Office Action Summary

10/574,617

YOKOYAMA ET AL.

DETAILED ACTION

FIG. 11B

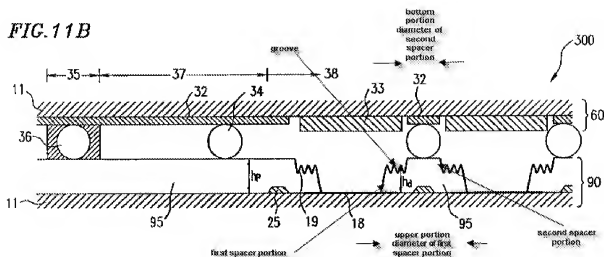
3. Claim 12 is rejected under 35 U.S.C. 102(b) as being anticipated by Kijima et al. (US 6259500).

Regarding claim 12, Kijima discloses a substrate with a spacer comprising a substrate (11); and a spacer (95) formed on said substrate, wherein said spacer has at least a first spacer portion, and a second spacer portion formed above said first spacer portion, and an upper portion of said first spacer portion has a larger diameter than a bottom of said second spacer portion, and the upper portion of said first spacer portion has a groove surrounding said second spacer portion in a plan view (Fig. 11B).
